FOUNDATION INVESTIGATION  
PROPOSED CROSSING  
LEEBURN CREEK - HIGHWAY 638  
W.P. 19-76-04, SITE 38S-122  
DISTRICT 18, SAULT STE. MARIE

Ref. No. 78-6-19

Re: Leeburn Creek Bridge  
W.P. 19-76-04, Site 38S-122  
District 18, Sault Ste. Marie

We have reviewed the Preliminary Bridge Plan Drawing 38S-122-P1 for this project. Our comments are as follows.

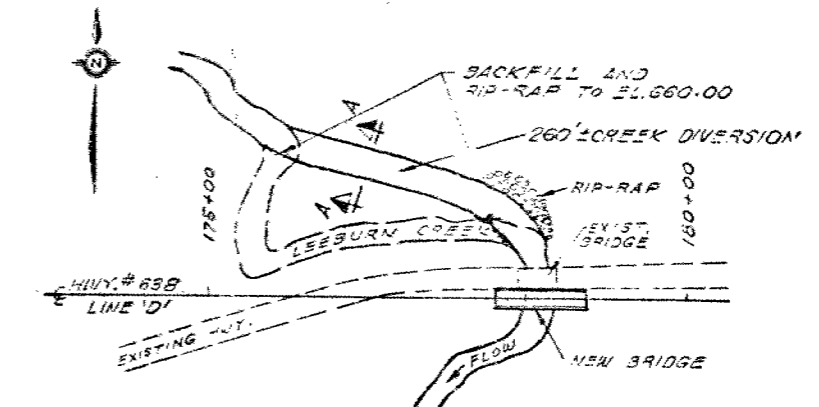
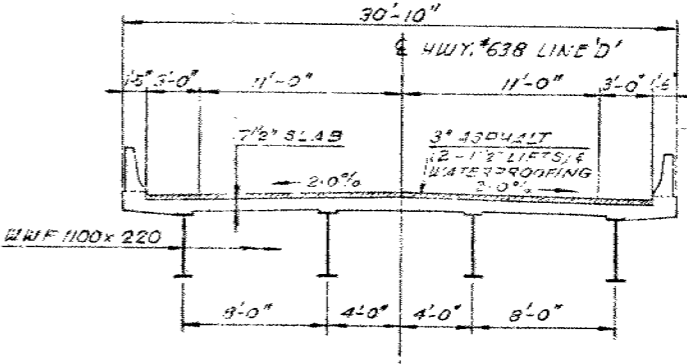
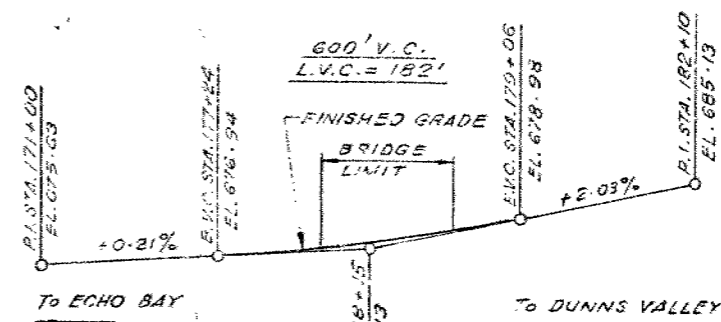
3. The pile length for the east abutment listed in Design Drawing #3 should be increased from 61 feet to 65 feet.
